Access Compliance Report

Public Rights-of-Way

Intersection ID: 15187	Main Street: FORTUNE_ST	Cross Street: MONROE_RD	Location: E
ADA ID: 5AC2E7D79757	Ramp Type: Perp	Initial Pass/Fail: Fail	Overall Compliance: No
Severity Score: 48.75			
Codes/Mitigation Info/Possible Solution		Field Measurements/Component Compliance

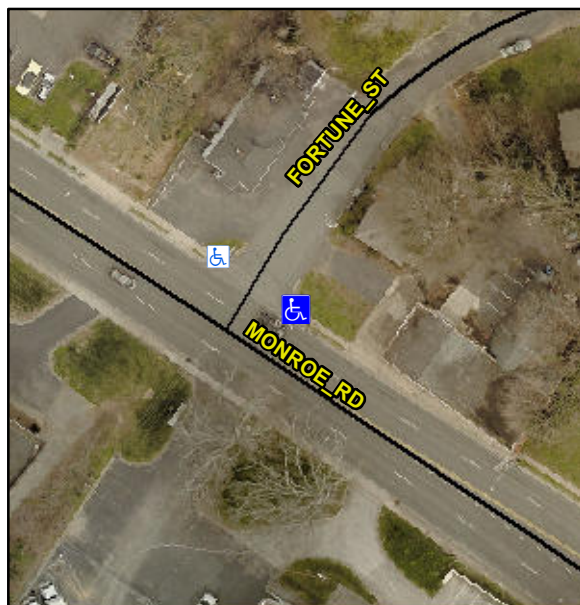
Not Found, R304.5.1, R304.2.2, R304.5.3

Compliance	Description	Data	Compliance	Description	Data
N/A	Ramp Length (in)	73.0	No	Ramp Slope (%)	9.5
No	Ramp Width (in)	24.0	No	Ramp XSlope (%)	4.8
N/A	Flare Type LT	N/A	N/A	Flare Type RT	N/A
N/A	Flare Slope LT (%)	N/A	N/A	Flare Slope RT (%)	N/A
N/A	Flare Traversable LT?	N/A	N/A	Flare Traversable RT?	N/A
N/A	Landing Length (in)	N/A	N/A	DWS Provided?	N/A
N/A	Landing Width (in)	N/A	N/A	DWS Contrast?	N/A
N/A	Landing Slope (%)	N/A	N/A	DWS Length (in)	N/A
N/A	Landing X Slope (%)	N/A	N/A	DWS Full Width?	N/A
N/A	Landing Curb? (Y/N)	N/A	N/A	DWS Offset (in)	N/A
N/A	Shared Landing?	N/A			
N/A	Gutter Ponding?	N/A	N/A	Gutter Slope (%)	N/A
N/A	Gutter Lip Ht (in)	2.0	N/A	Gutter X Slope (%)	N/A
N/A	Painted X Walk1?	No	N/A	Painted X Walk2?	N/A
	X Walk 1 Direction	To NW		X Walk 2 Direction	N/A
N/A	X Walk 1 Width (in)	N/A	N/A	X Walk 2 Width (in)	N/A
	X Walk 1 Slope (%)	0.0		X Walk 2 Slope (%)	N/A
	X Walk 1 X Slope (%)	6.1		X Walk 2 X Slope (%)	N/A

Remove & Replace Entire Ramp.
